ADDENDUM

Project Name: High School Improvements Addendum No.: **One (1)**
Darrouzett Independent School District Date: 06/29/09
102 West Kansas Project No.: 08003
Darrouzett, Texas 79024

SUPPLEMENTARY DRAWING NO. 2

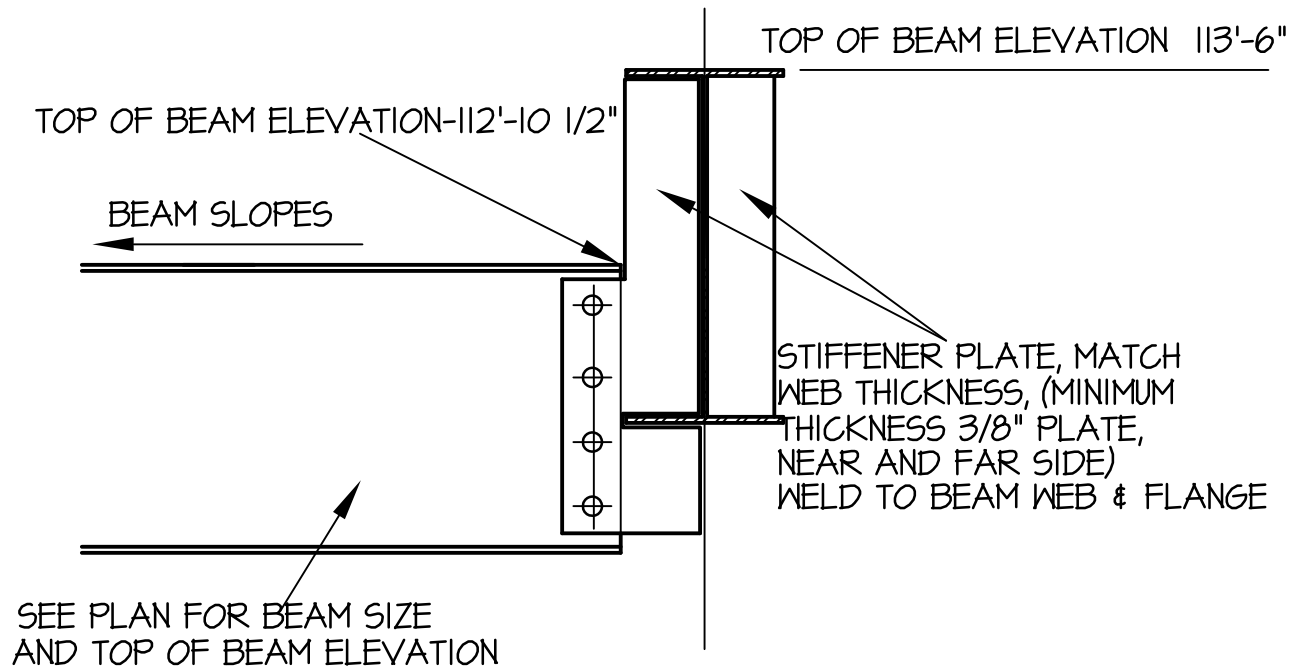
- Item No. Five:** In the Drawings, Sheet S2; for clarification purposes refer to the area between grid line 3 and north of it, and grid line N and west of it. Also, refer to 04/A12. The server room B220 has been added. Modify the floor area to accommodate this by adding two (2) stub columns and new beam W8x18. As shown in the attached Supplemental Drawing SD-2.

- Item No. Six:** In the Drawings, Sheet S2 and SD-2; for clarification purposes slab elevation of area west of the hatch marks shall be 102'-6 1/4". The slab elevation of area east of the hatch mark shall be 100'-0".

SUPPLEMENTARY DRAWING NO. 3

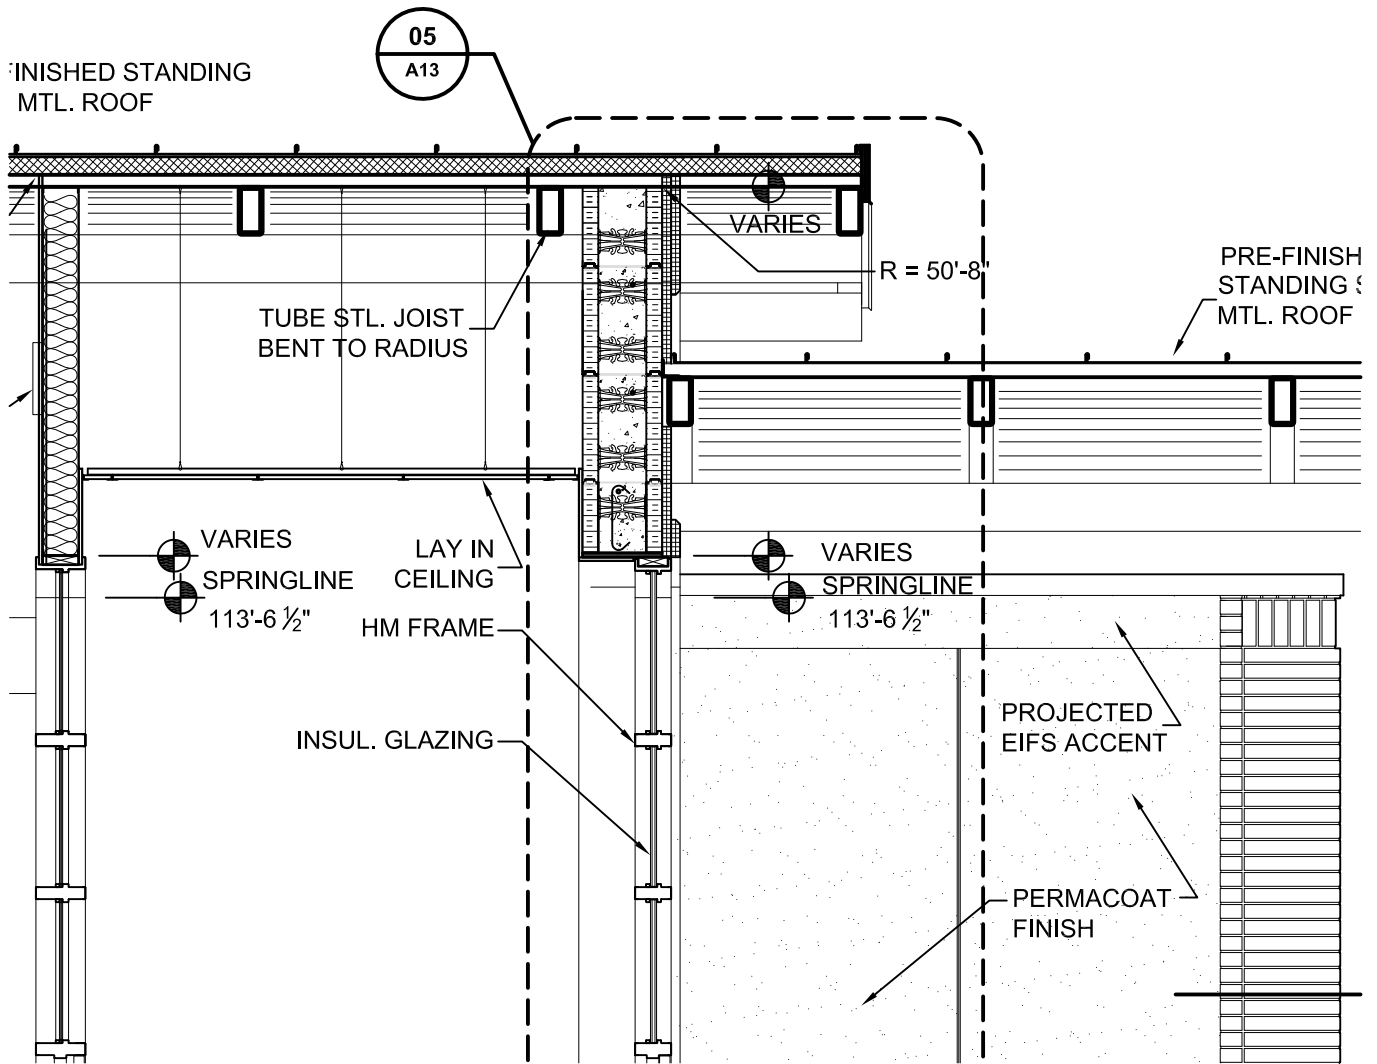
- Item No. Nine:** In the Drawings, Sheet S4; for clarification purposes framing plan area "C". The W14x22 beams along grids 2' and 3' shall be attached to beam W18x35 along grid C' as shown in the attached Supplemental Drawing SD-3.

SUPPLEMENTAL DRAWING NO. SD-4

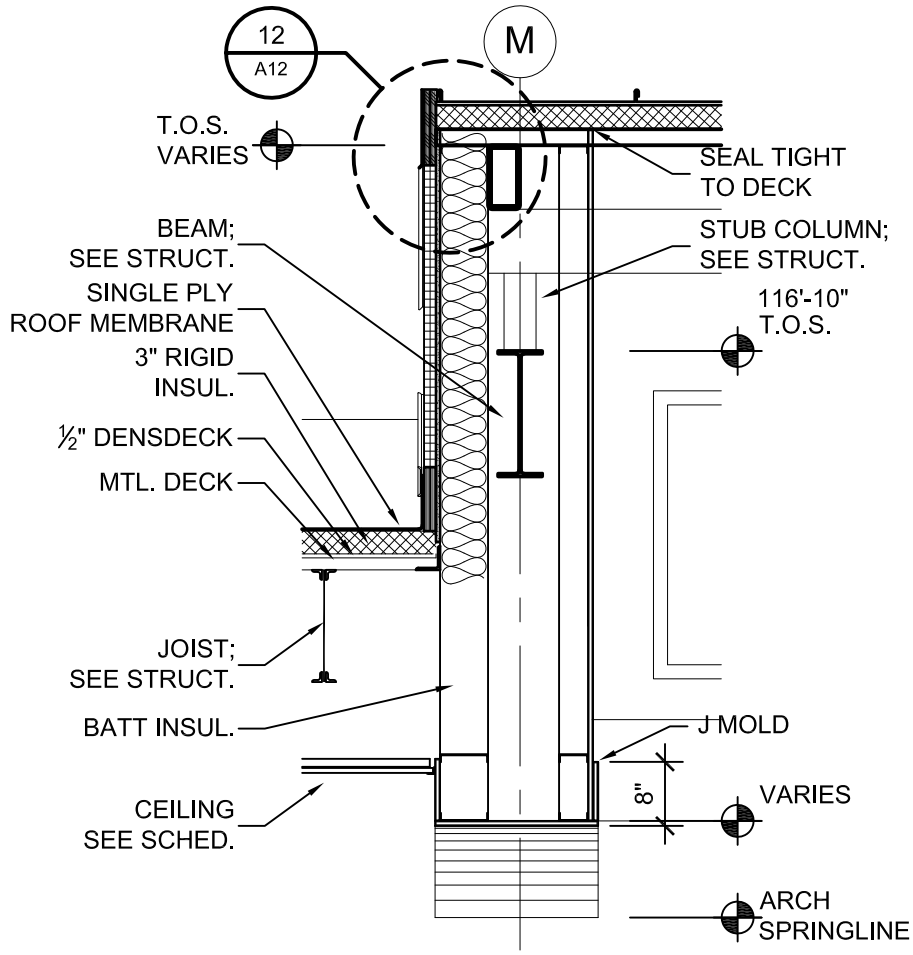
- Item No. Twelve:** In the Drawings, Sheet A9, Section 01; for clarification purposes top of wall Radius for 8" ICF wall is 50'-8" as shown in attached Supplemental Drawing SD-4.

SUPPLEMENTAL DRAWING NO. SD-5

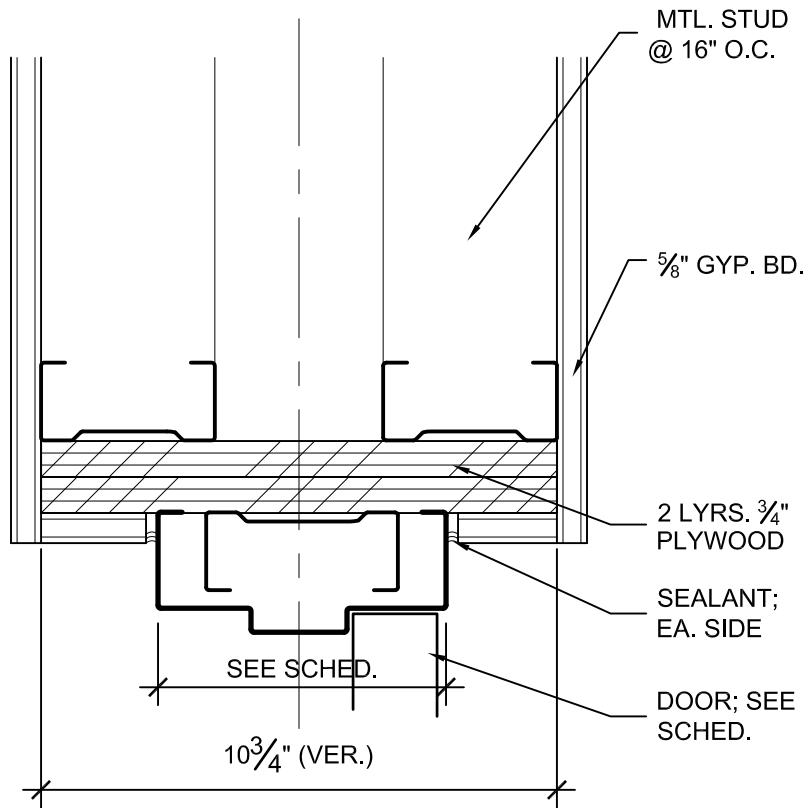
- Item No. Thirteen:** In the Drawings, Sheet A13, for clarification purposes make the following changes and /or revisions.
A. Replace Wall Section 07/A13 in the plans with Supplemental Drawing SD-5.
